Product Change Notification / ASER-24QQEH990

CCB 4753 Final Notice: Qualification of STA as an additional assembly site for selected LAN8710Axxx device family available in 32L VQFN (5x5x0.9mm) package.

**CCB 4753**  
**Pre and Post Change Summary**  
**PCN #: ASER-24QQEH990**

ASE

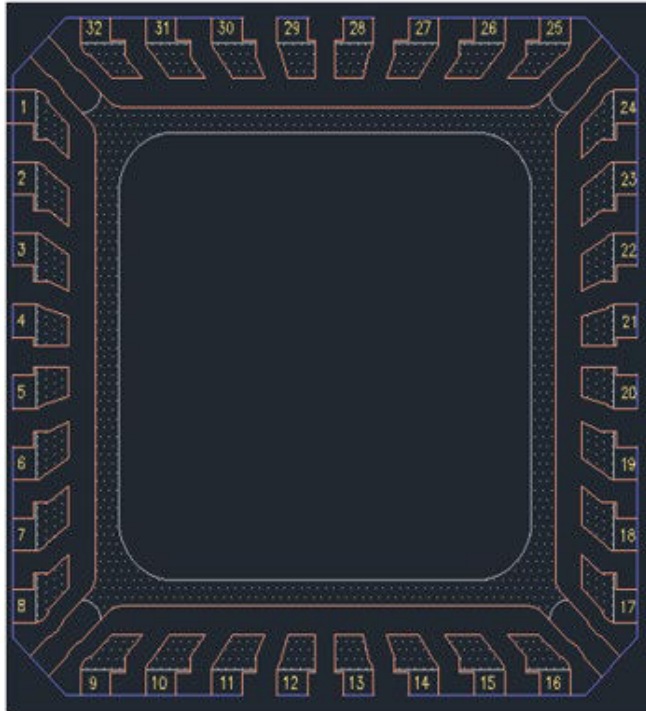
# Lead Frame Comparison Comparison
